ADDENDUM

Date Issued:	April 8, 2019
Project:	Intermountain Healthcare IMC- Cath Lab #6 Remodel 5121 South Cottonwood Street Murray, Utah 84107
Addendum Number:	1

ADDENDUM #1

PROJECT: IMC Bldg 5 L1 Cath Lab #6 Remodel

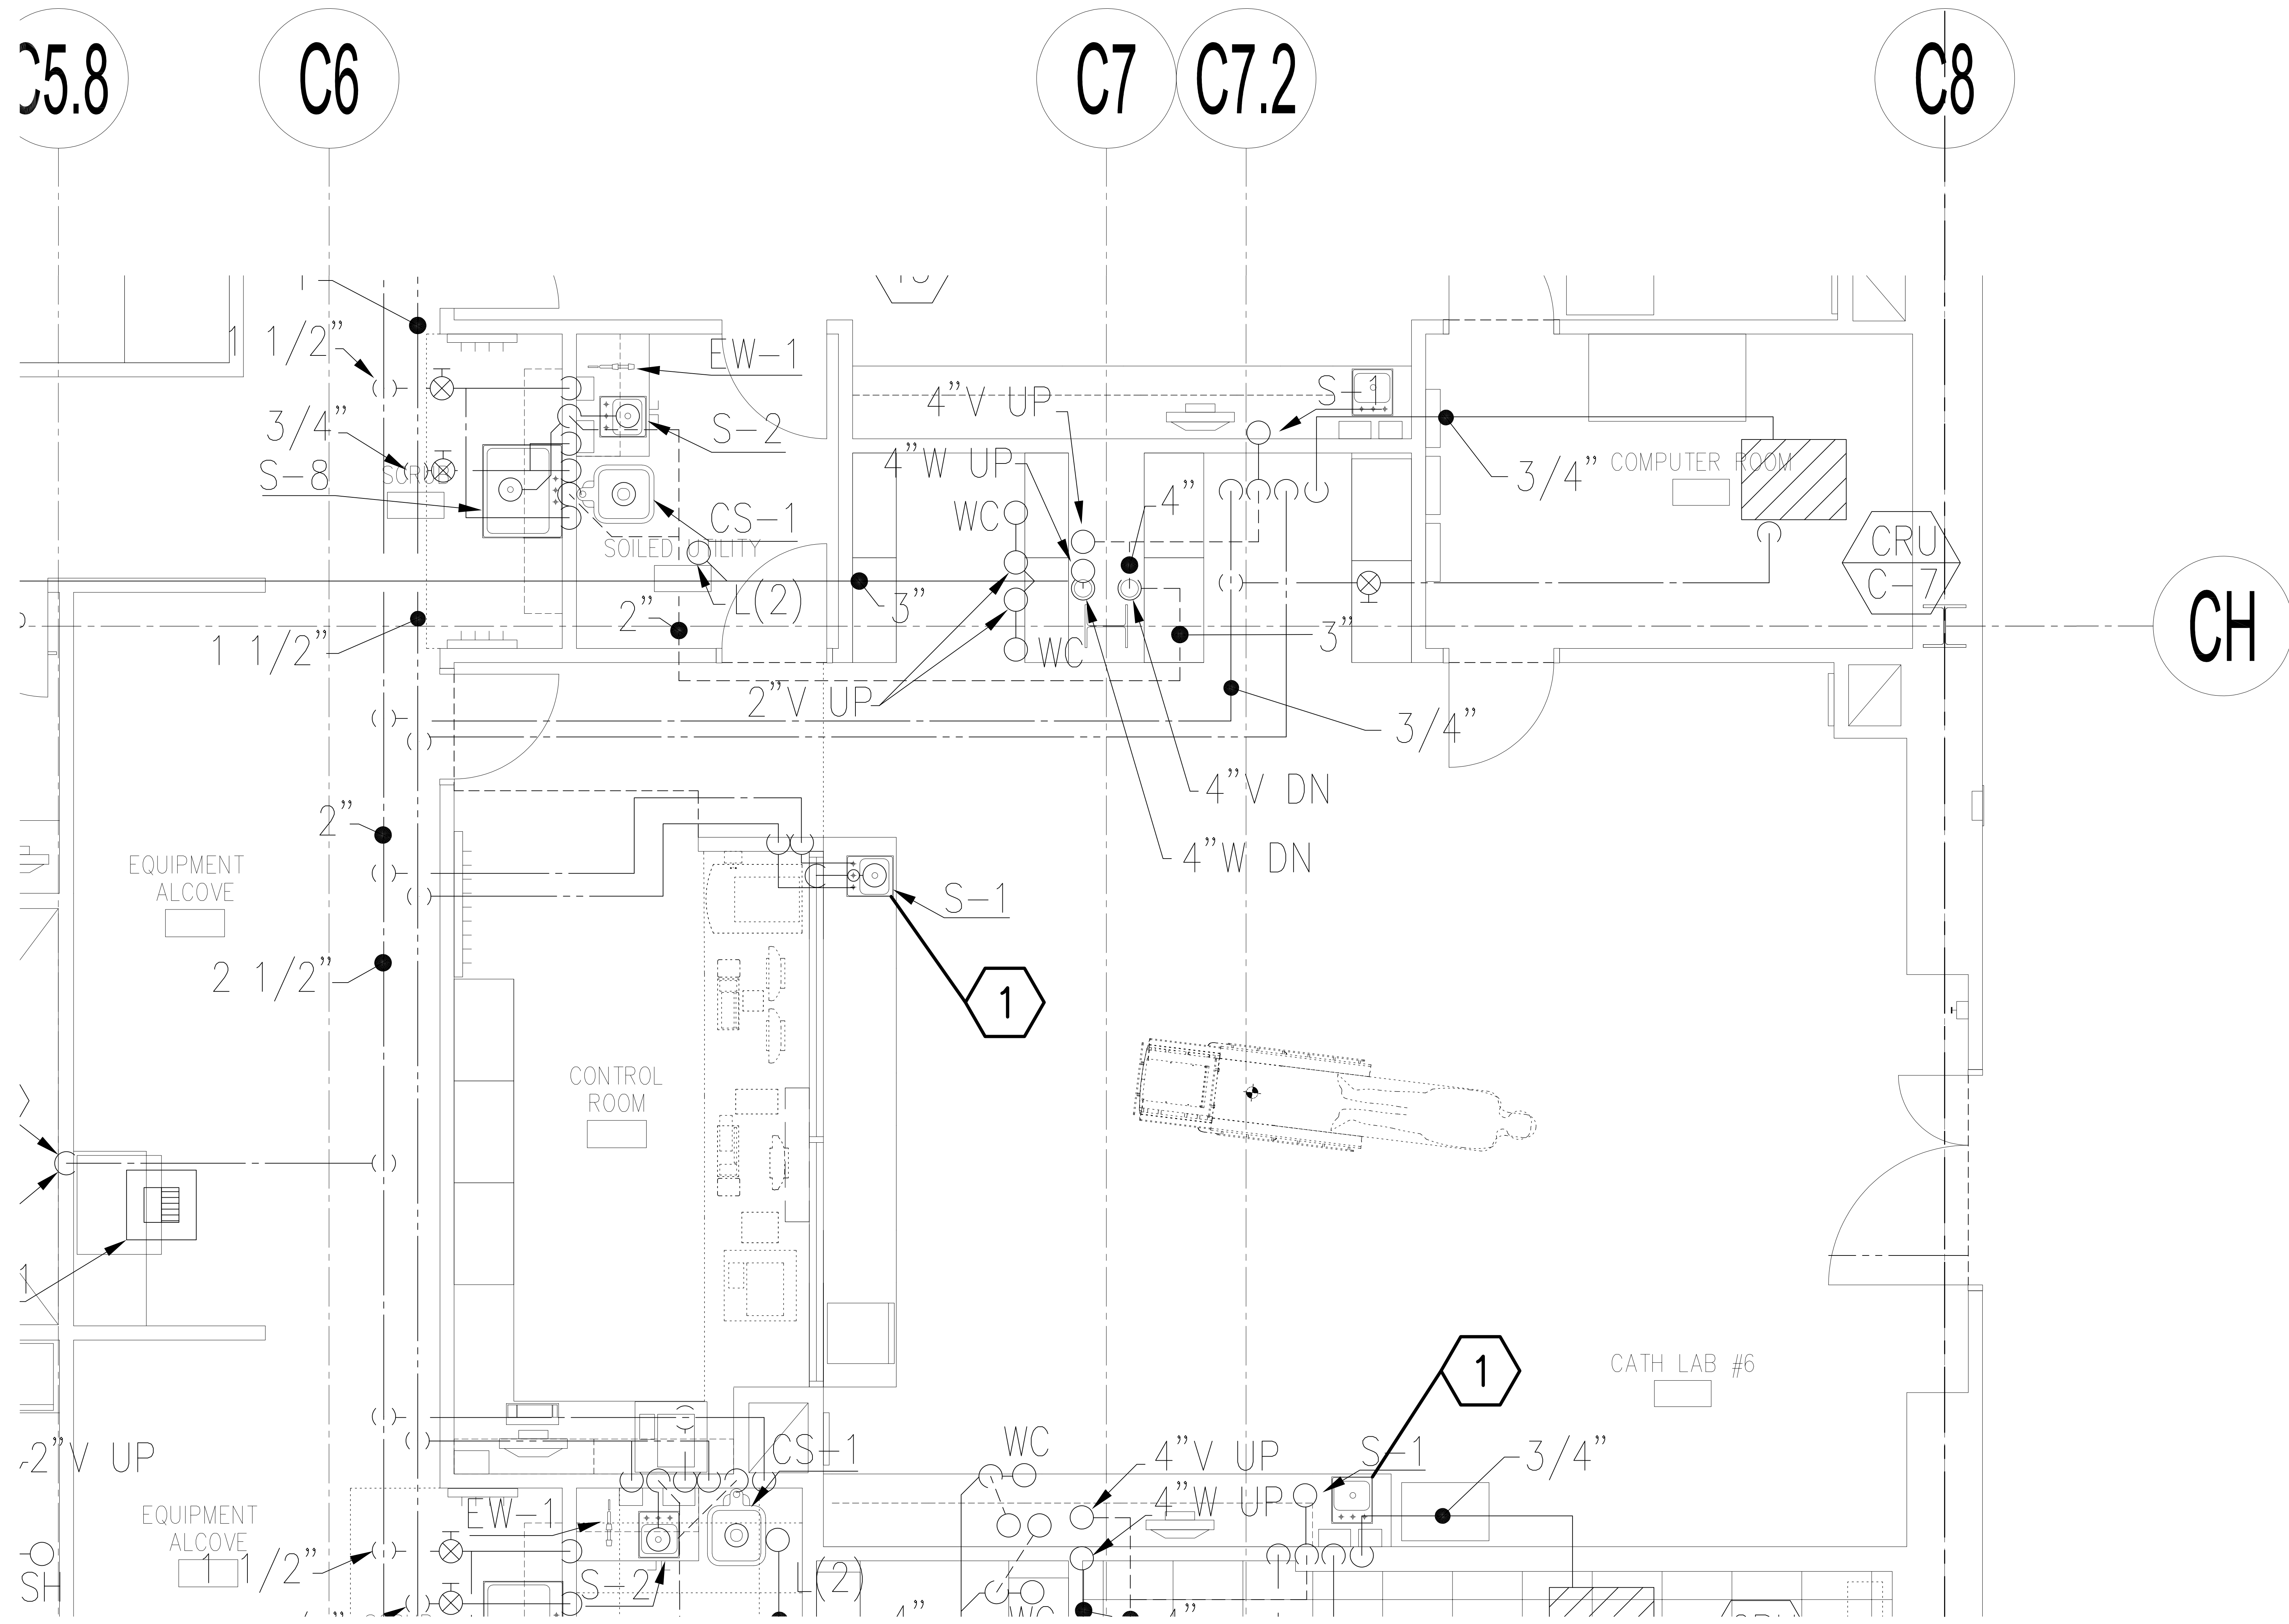
SHEET - M501 – Mechanical Schedules

1. Added grilles, registers and diffusers schedule.
2. Updated VAV Box schedule.

1 PLUMBING DEMOLITION PLAN
SCALE: 1/2" = 1'-0"

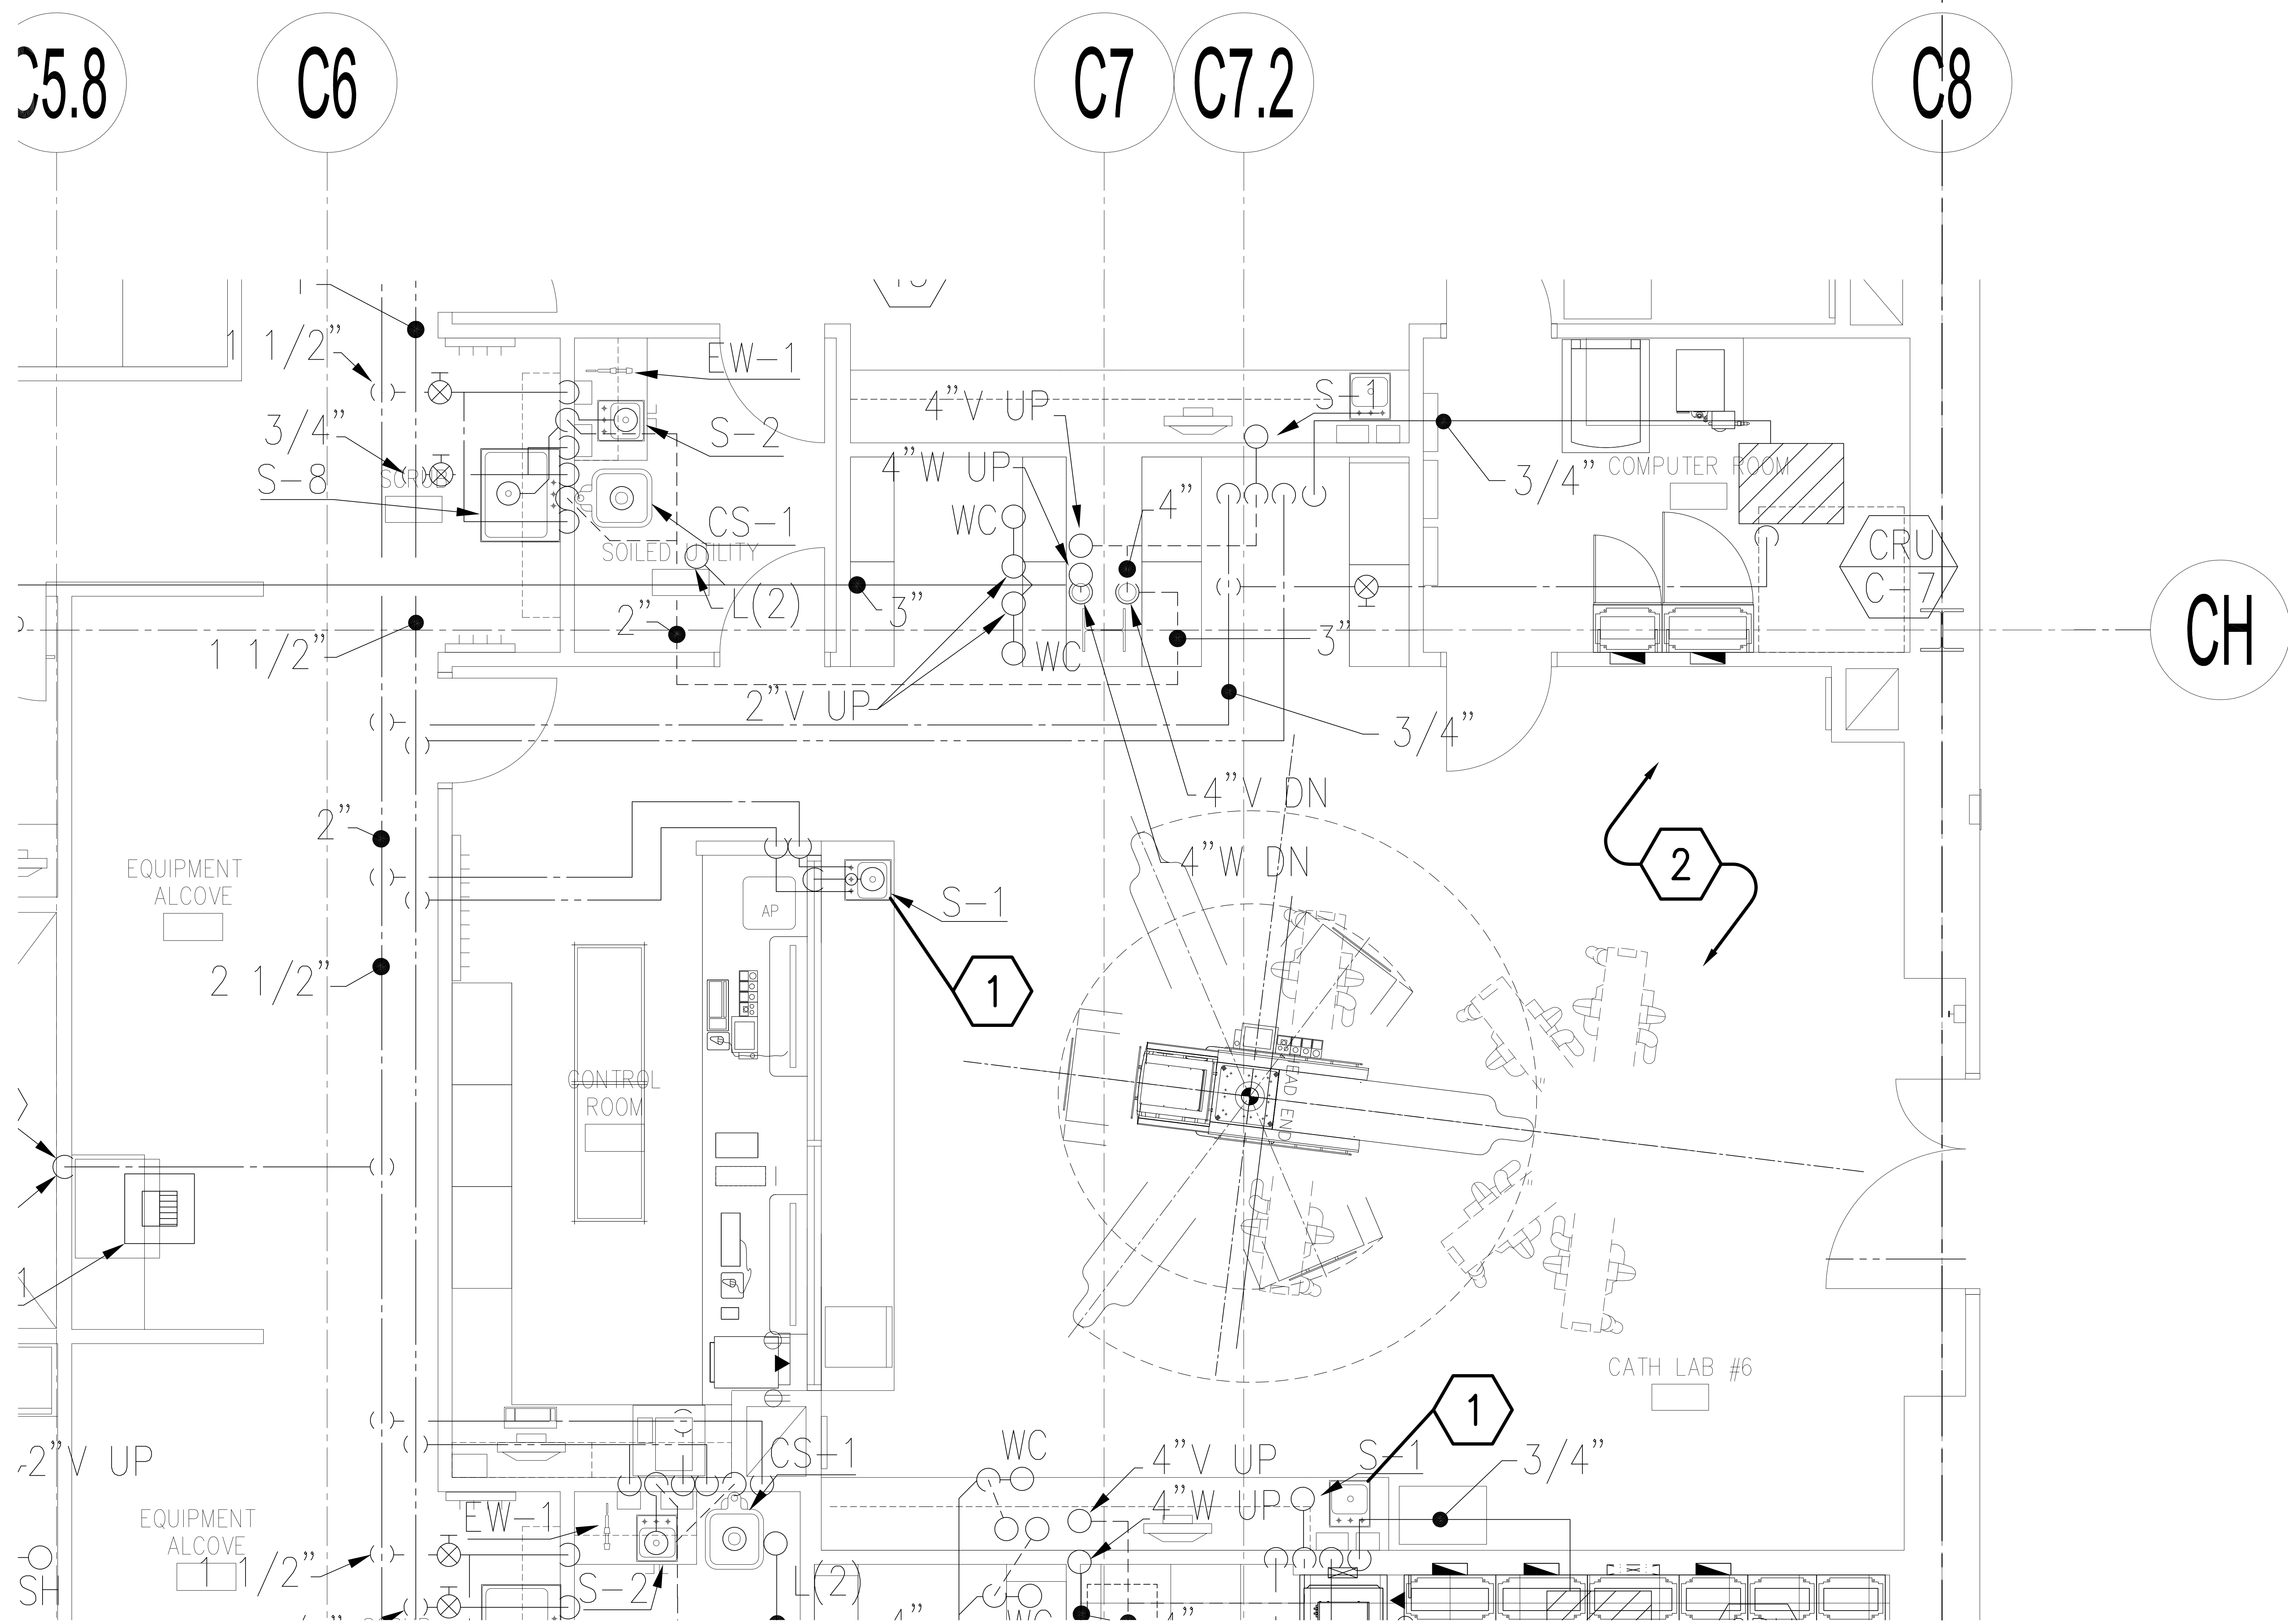
SHEET - P101 – Plumbing Demolition Plan

1. Keyed note revised.

1 LEVEL 1 POWER PLAN
SCALE: 1/4" = 1'-0"

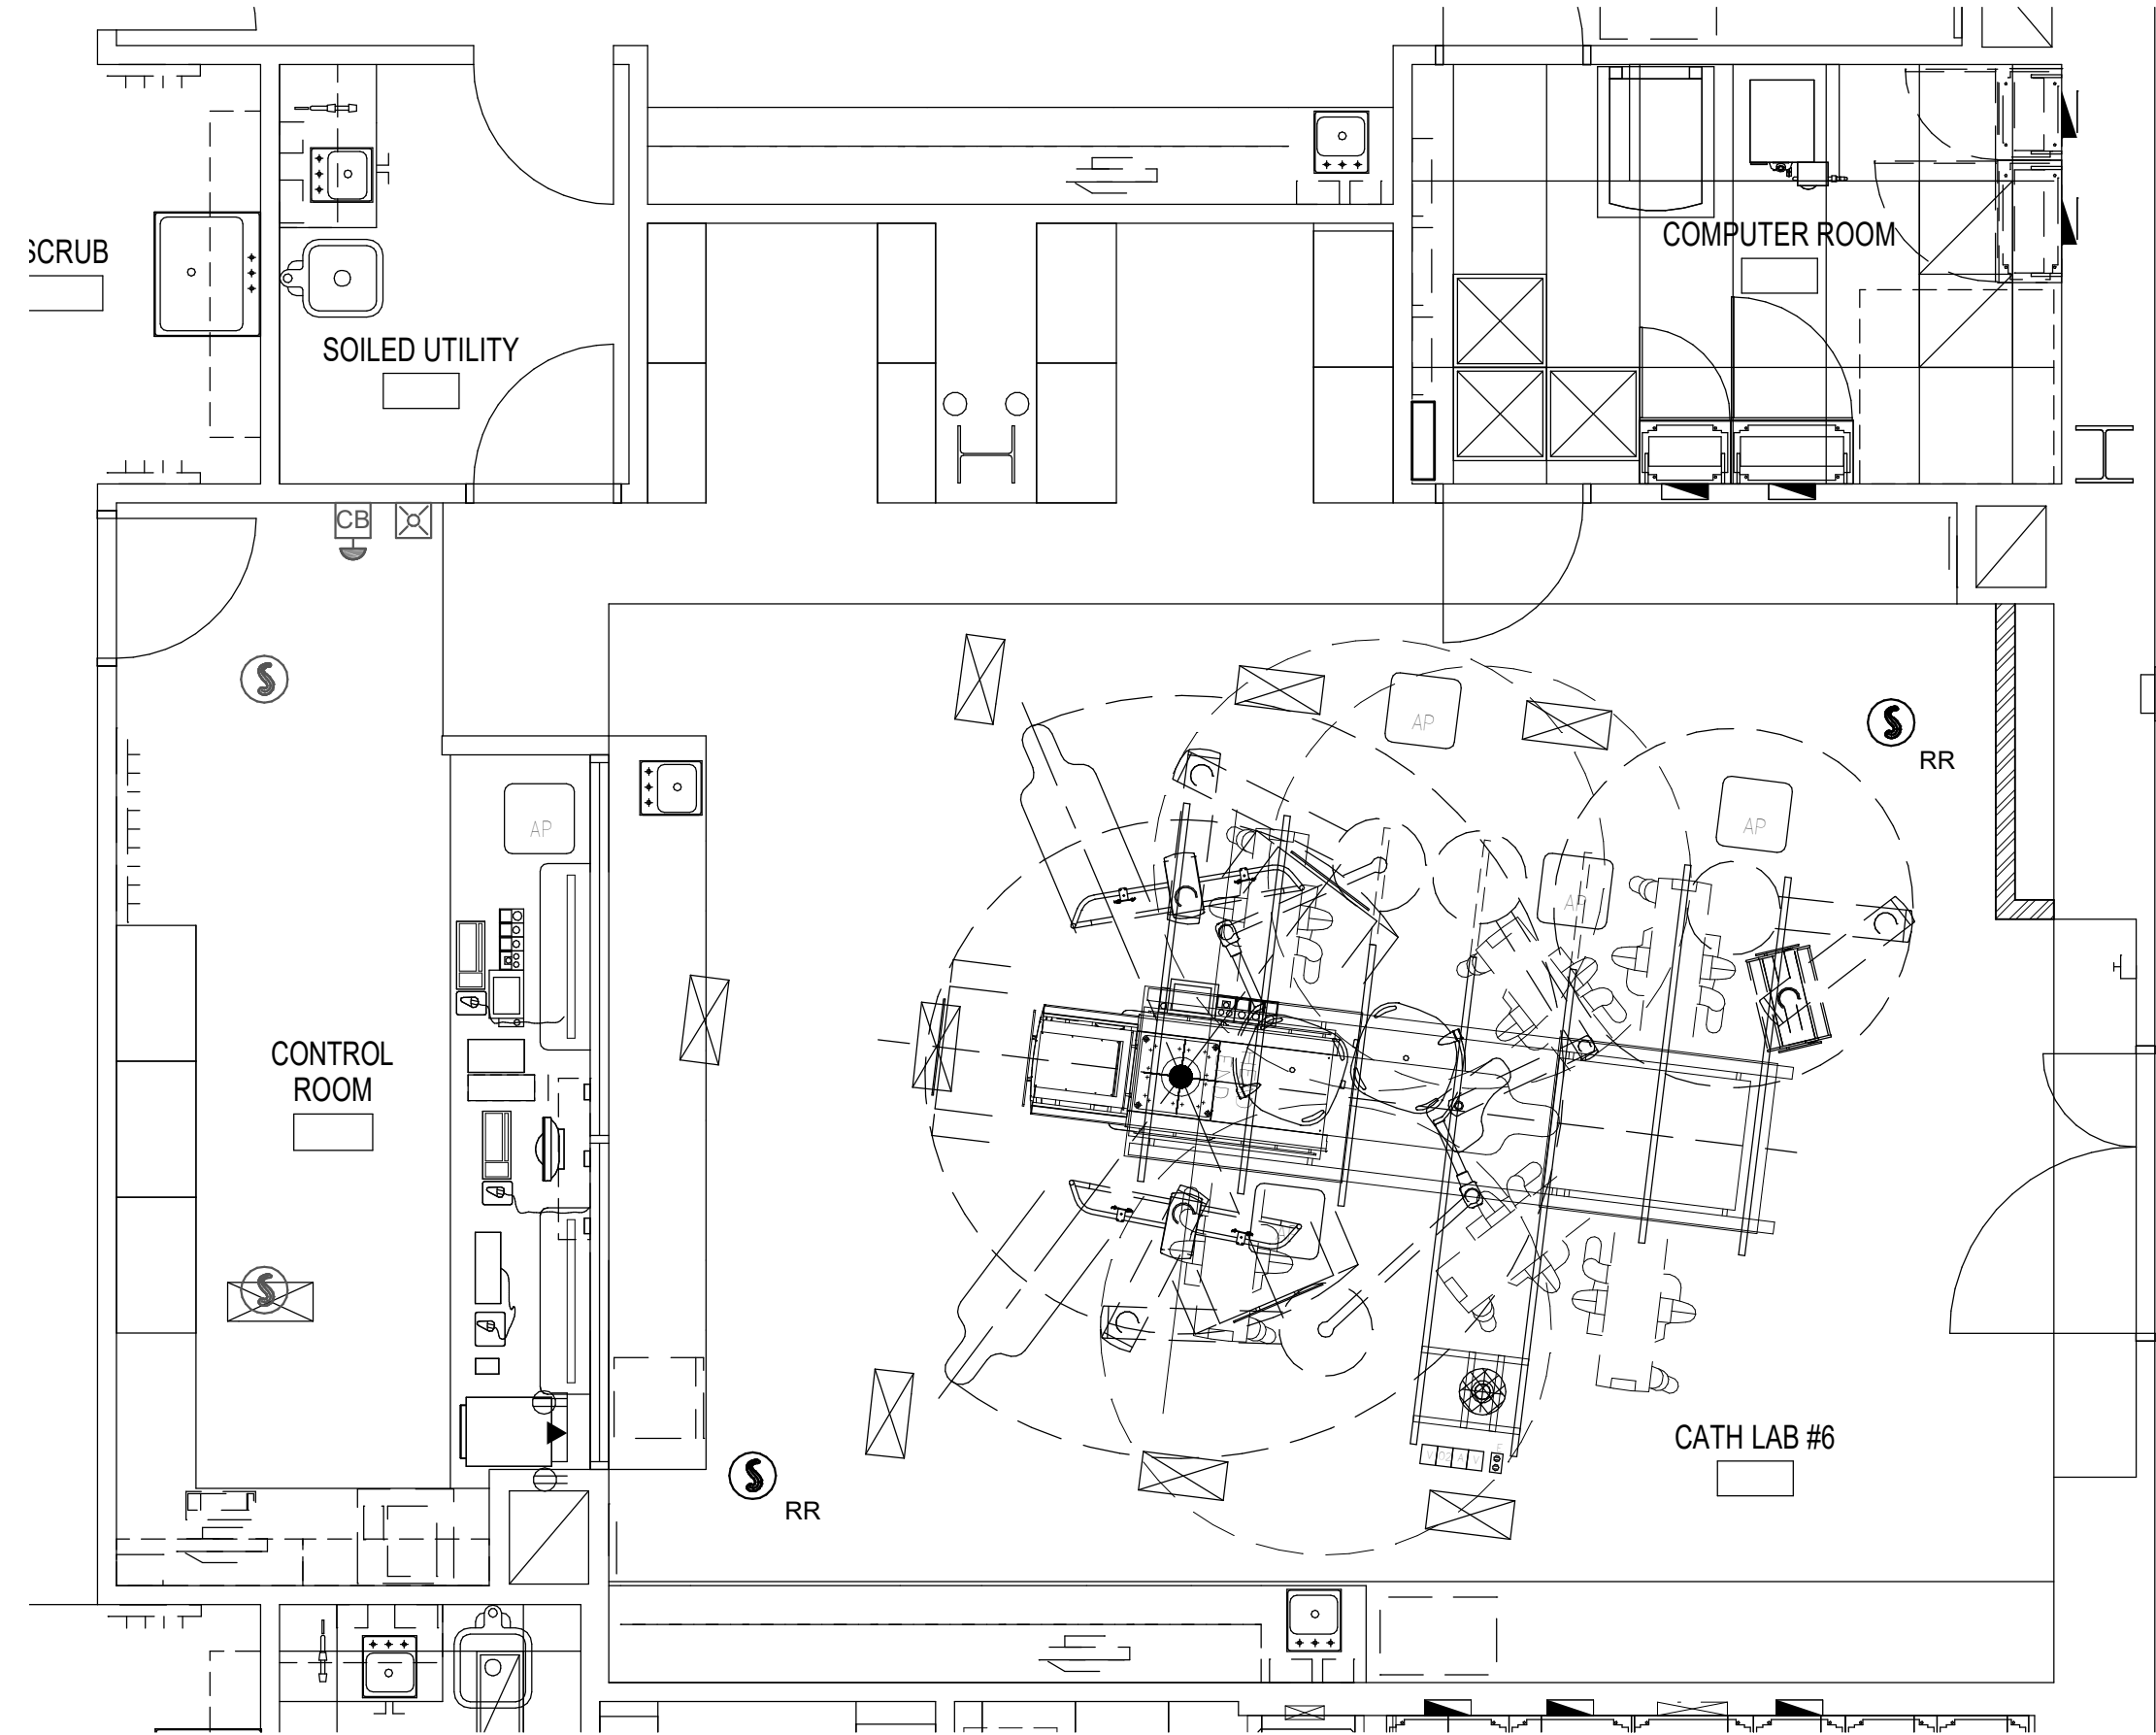
1. Detail #1: Added conduit and data cable for video switch. (Keynote #12)
2. Detail #2: Revised lighting to match existing light locations and removed one can light.
3. Detail #3: Revised existing light locations and removed one can light.
